PO Change Order Request Form

Change Order

Project: **Roosevelt Modular Classrooms**
951 Dowling Ave.
San Leandro, CA 94577

CO #: 9
Date: 04/20/2021
Contract Date: 02/05/2020
DSA Application #: 01-118101
DSA File #: 01-35

Date

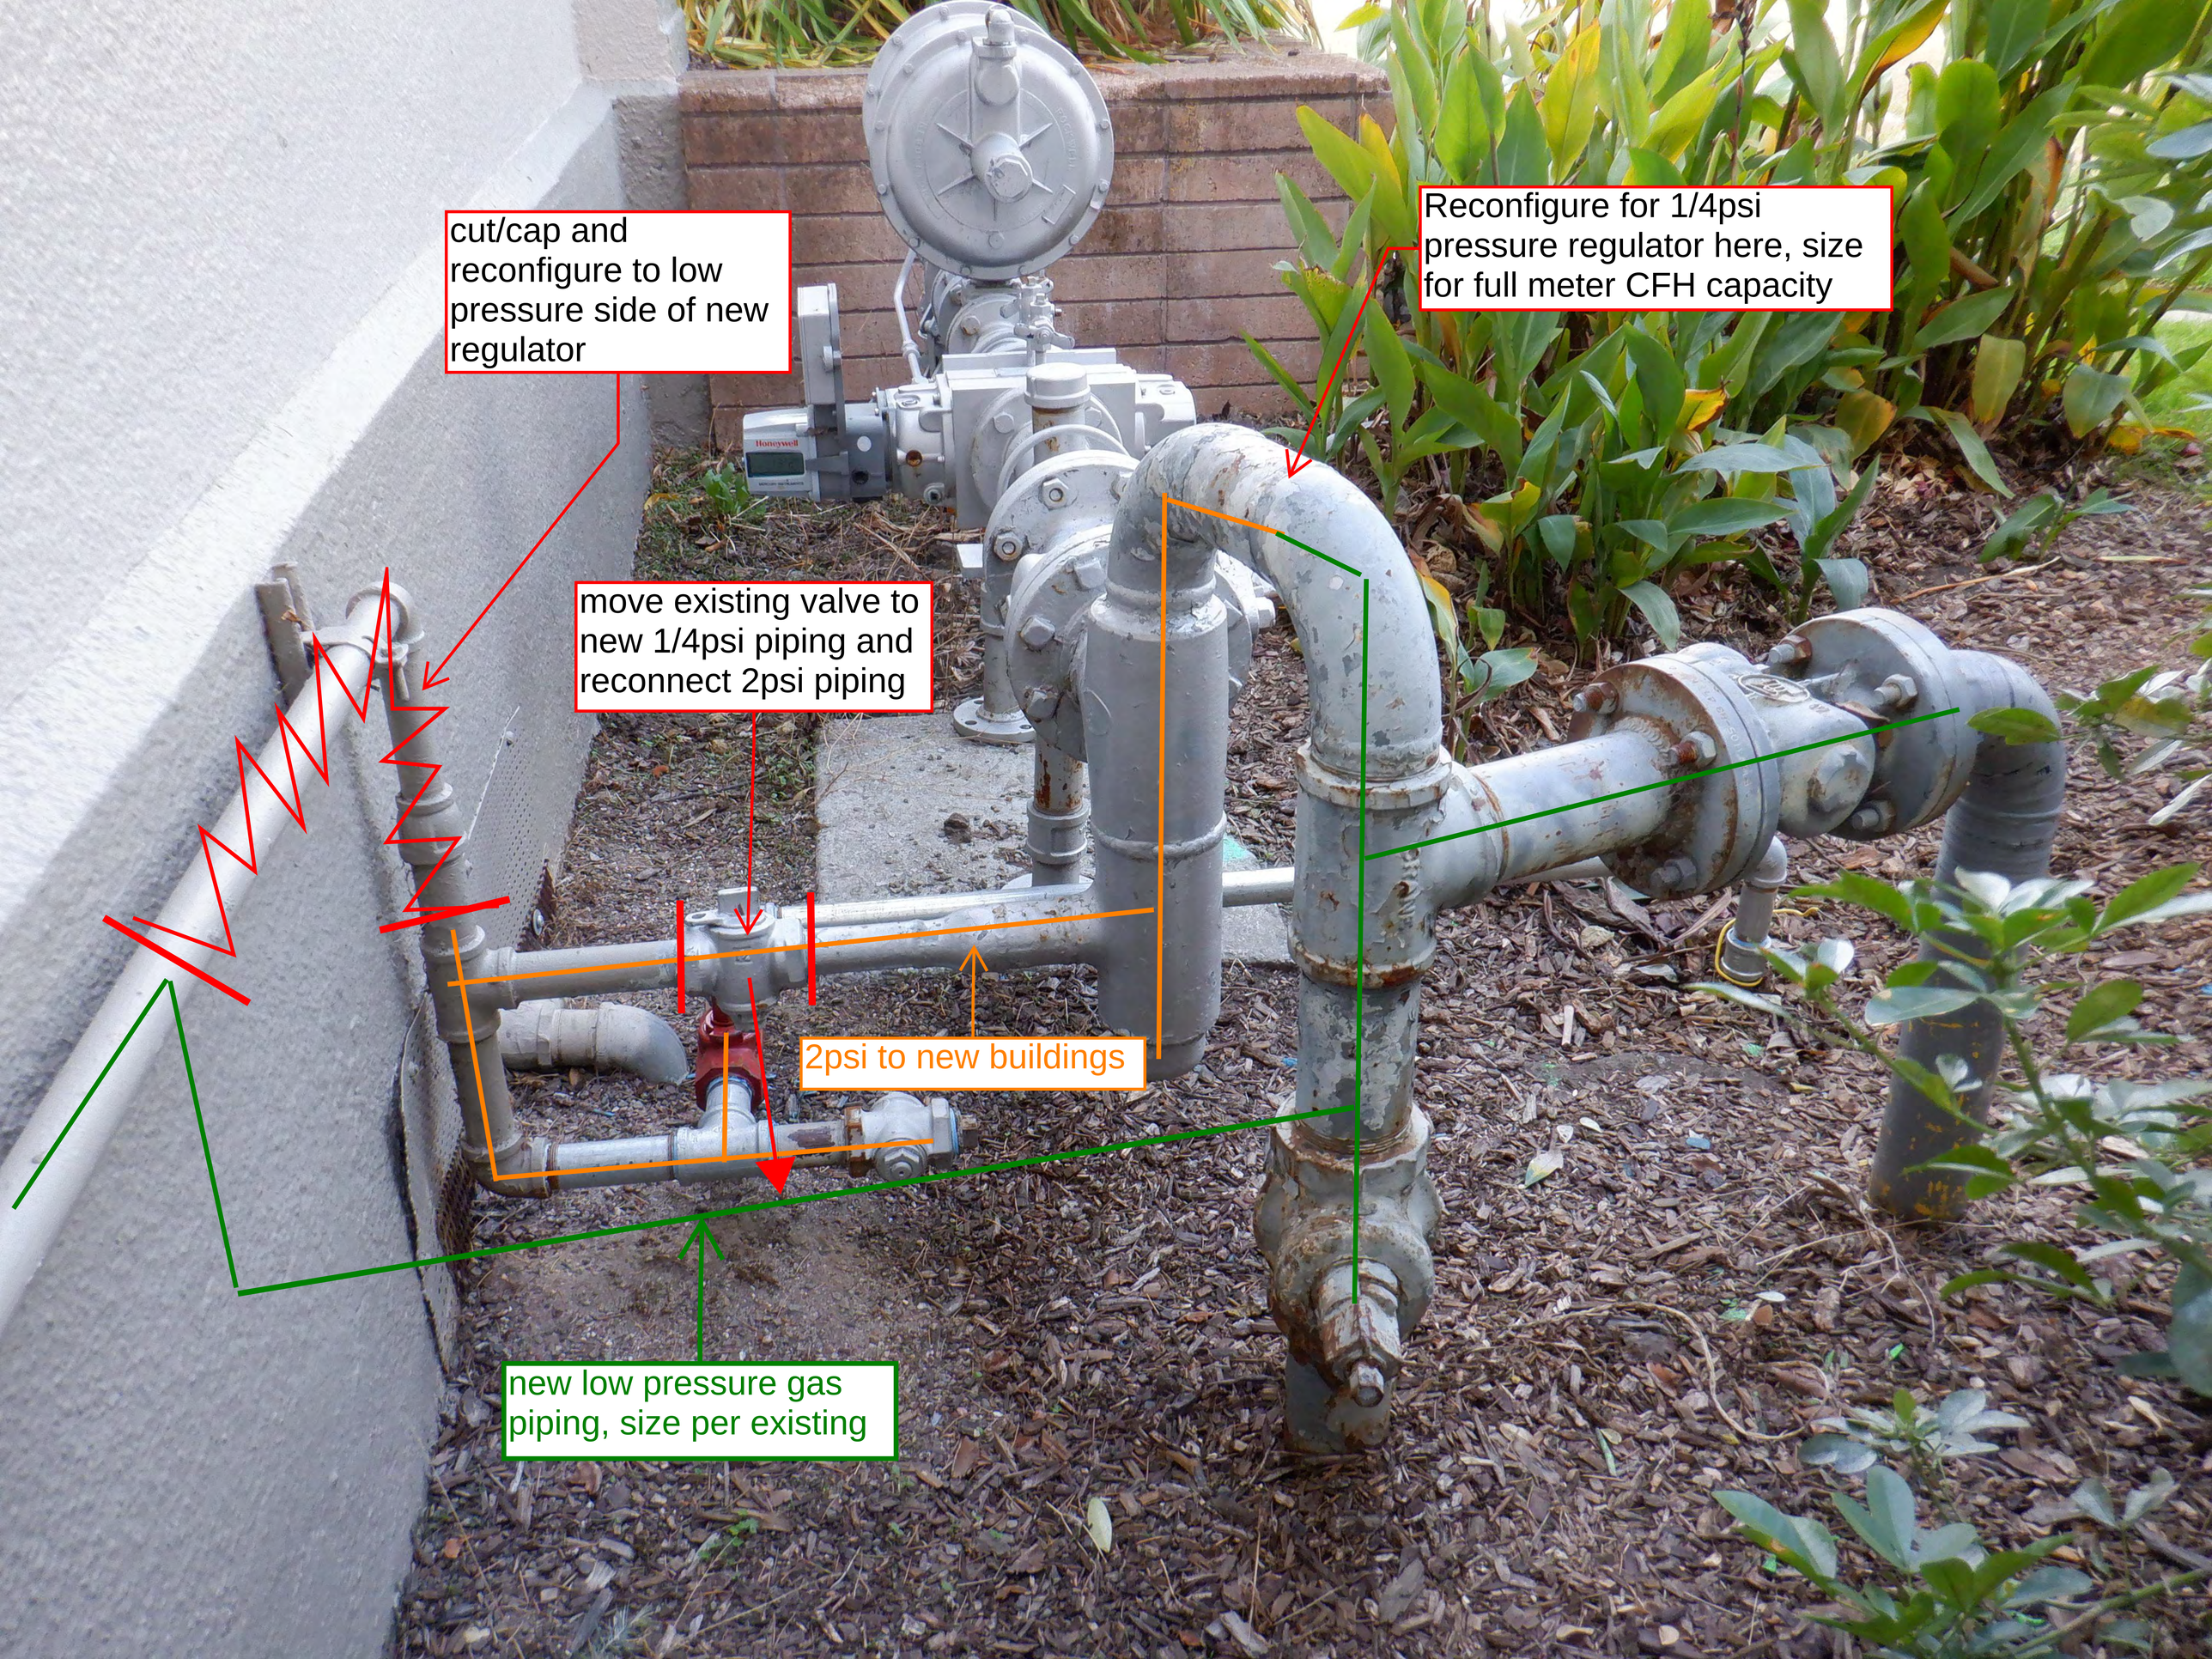
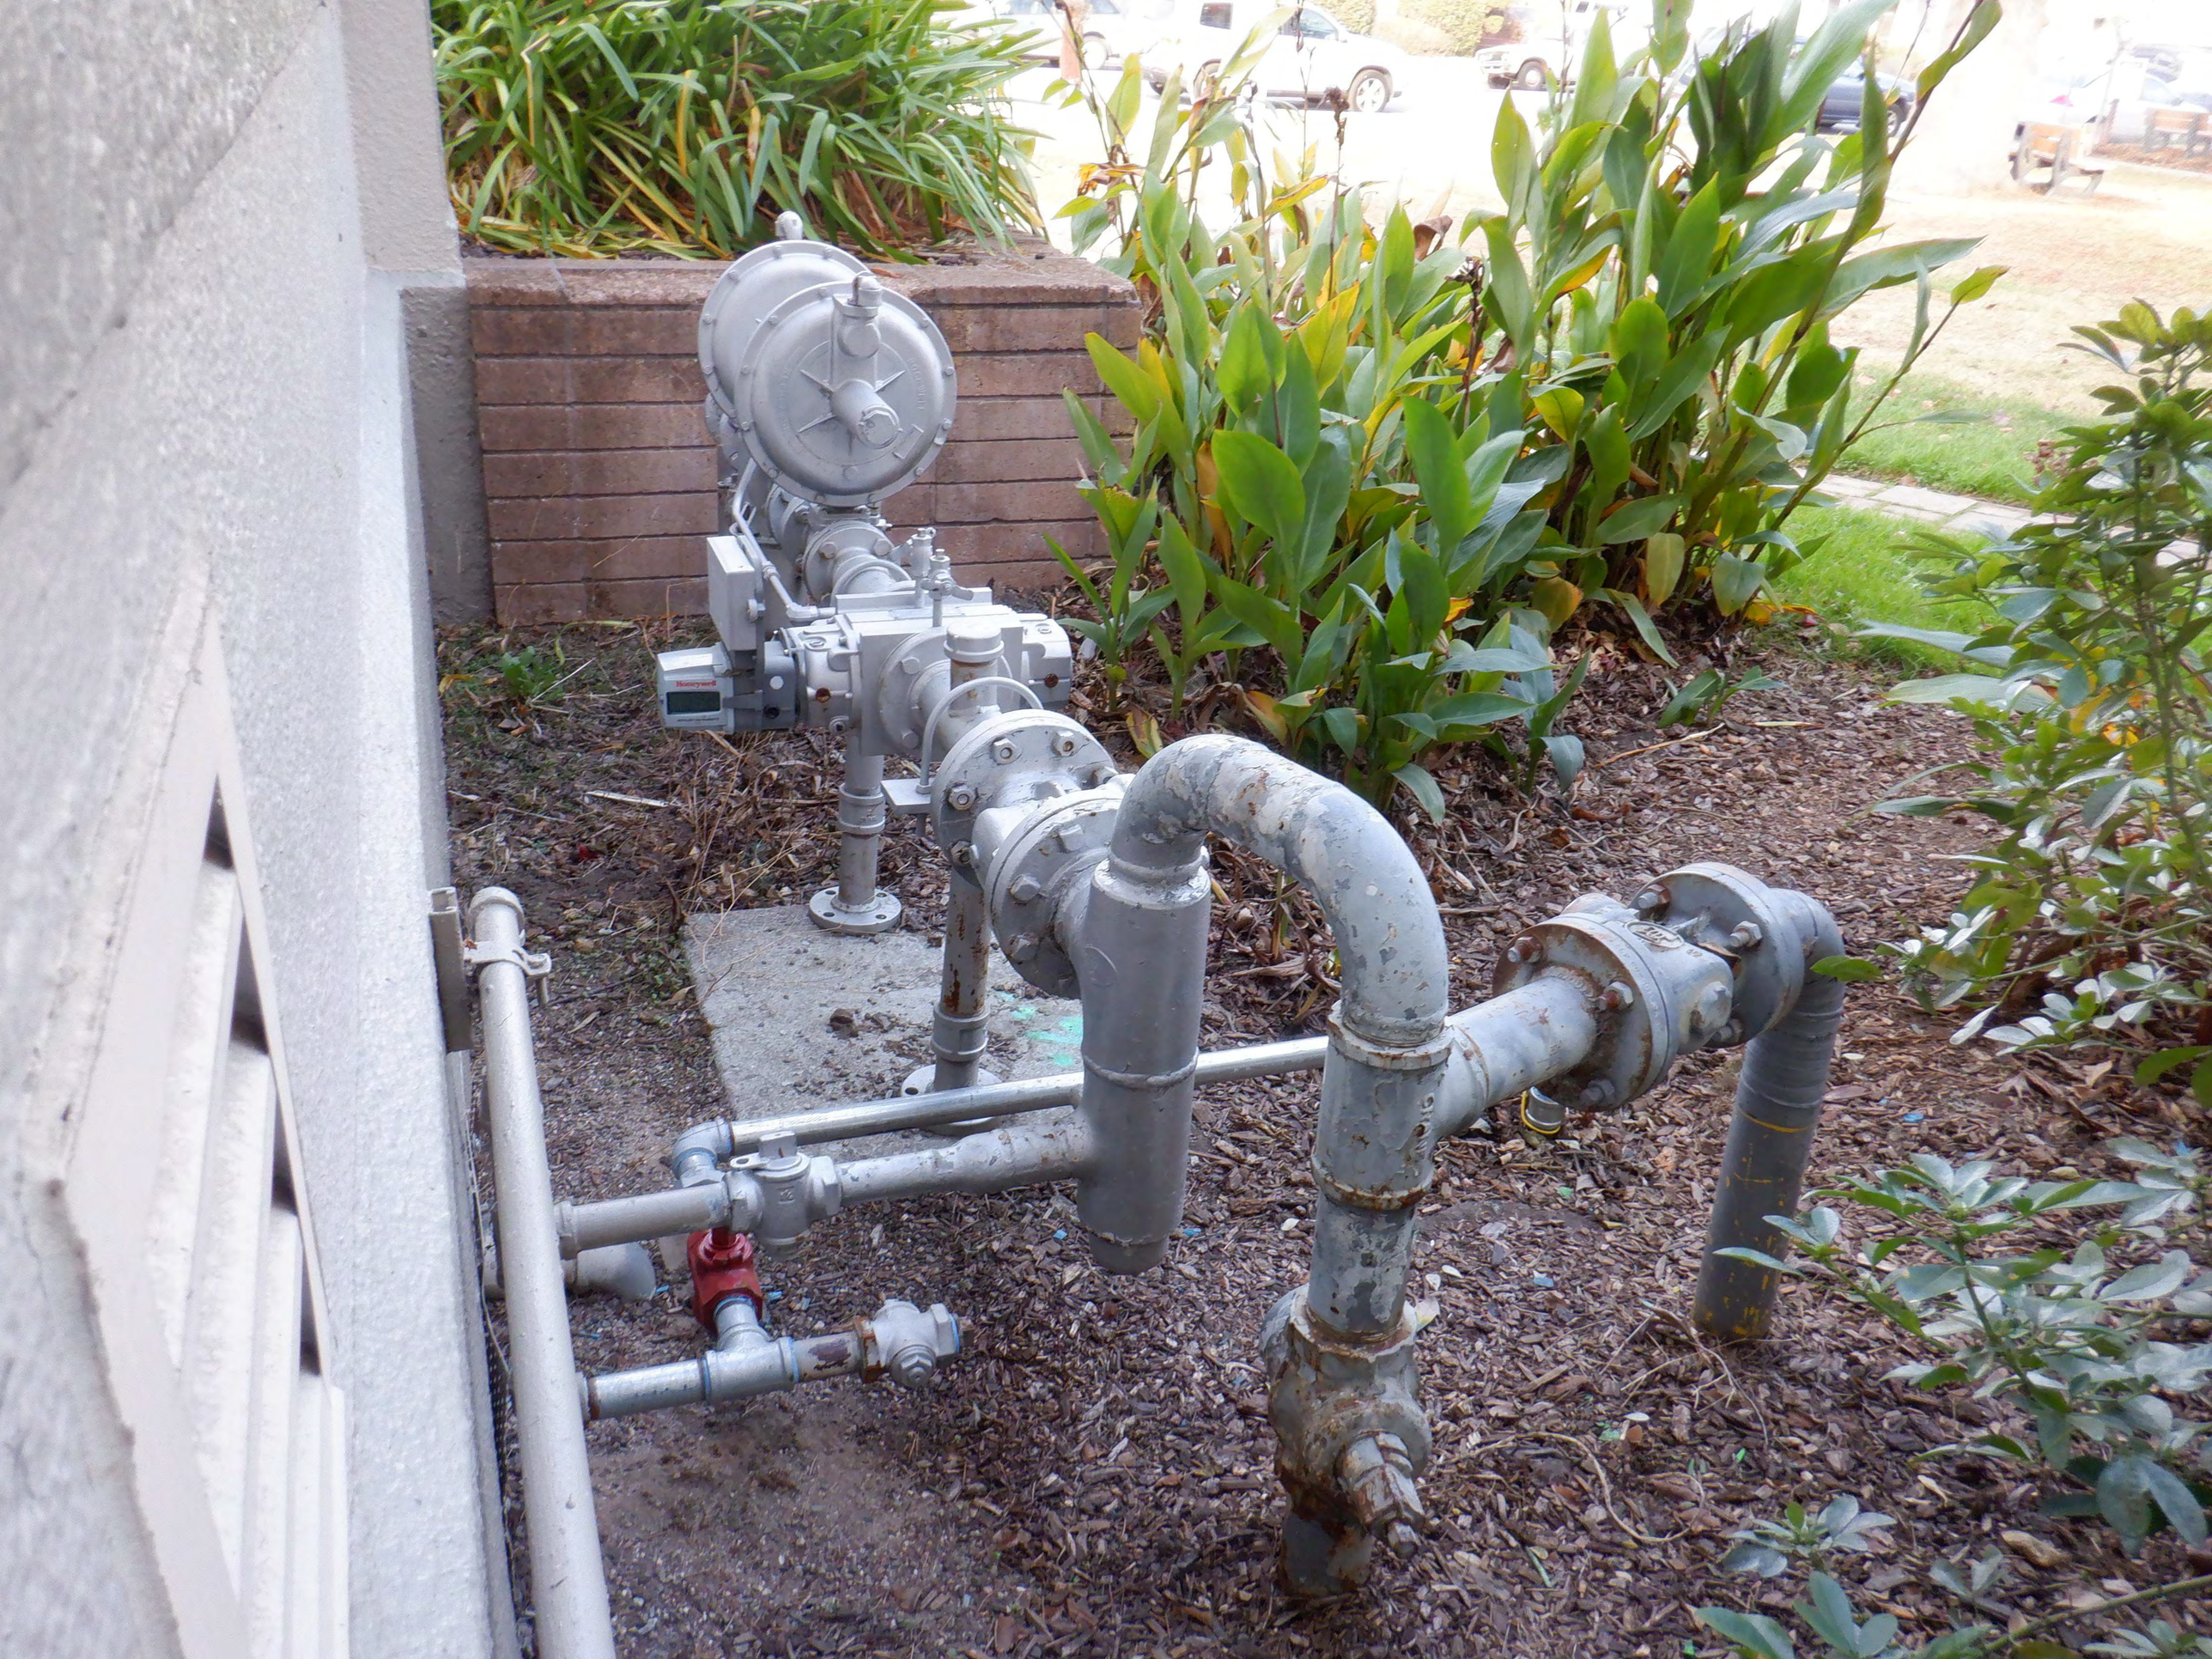
PG&E will be upping the gas pressure at the existing gas manifold to 2 PSI to allow for proper gas pressure at the new buildings. JLC would like to "T" on the Districts side of the meter. One side of the "T" will have a regulator installed on it to provide 1/4 PSI to the existing campus. The other side of the "T" will connect to the new underground gas line and provide 2 PSI of gas to the regulators installed at the new buildings.

Please review the attached photos and advise as to which items on the existing gas manifold can be removed/reconfigured to free up some room for the new "T" and regulator.

See sketches below, locate 1/4psi regulator after the T to the new 2psi building connection as indicated. Elbows can be reoriented to fit in new regulator. Size regulator for full CFH meter load. Ensure all relocated return to serve the same gas line as existing configuration.

Reconfigure for 1/4psi pressure regulator here, size for full meter CFH capacity
cut/cap and reconfigure to low pressure side of new regulator
1/4psi out to existing
move existing valve to new 1/4psi piping and reconnect 2psi piping
new low pressure gas piping, size per existing
1/4psi out to existing
2psi to new buildings
1/4psi out to existing

NEW PLAN

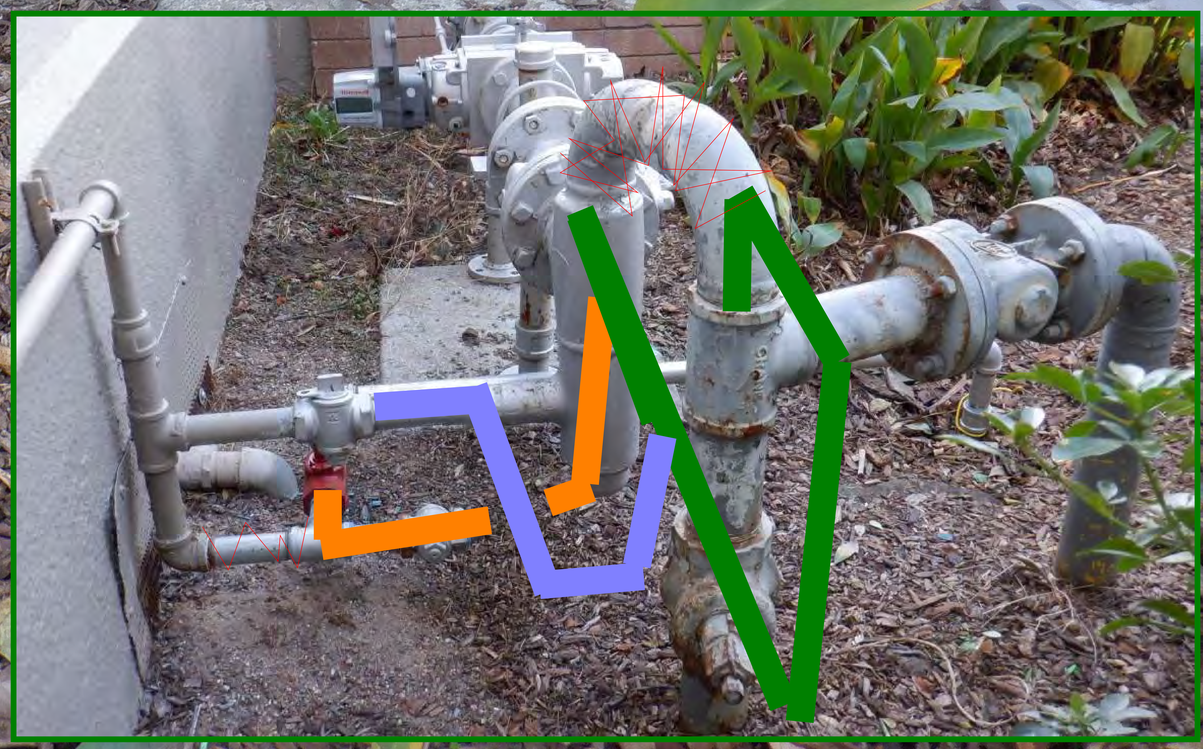
PG&E was onsite and changed out the regulator to provide 2 PSI gas to the campus. Attached is a photo showing what the new manifold assembly looks like. The solution provided in the response to RFI 058 does not work as there is simply not enough room to install a regulator for the existing buildings on campus on the house side of the PG&E gas manifold without completely reworking the existing underground gas risers. We feel that a meeting onsite with the engineer who designed the site gas is needed to come up with a solution to rework the this area. Please advise.

See attached sketch for direction. Demolish flanged and threaded section of pipe as indicated. Replace with campus pressure regulator added and reconnect piping per sketch. All work must be done on house site of set, PGE equipment set to remain as is. 2psi should be available to the new buildings, 1/4psi should be available to the rest of the existing campus. Response pending PGE review and approval prior to construction work.

Reconnect 1/4psi building supply after regulator here

New 1/4psi Pressure Regulator here

PGE valve to remain, bolt new flange at house side

Reconnect threaded 1/4psi building supply here

1/4psi piping to run behind (E) up and back over into threaded connection

Connect 2psi to new buildings on meter side of regulator
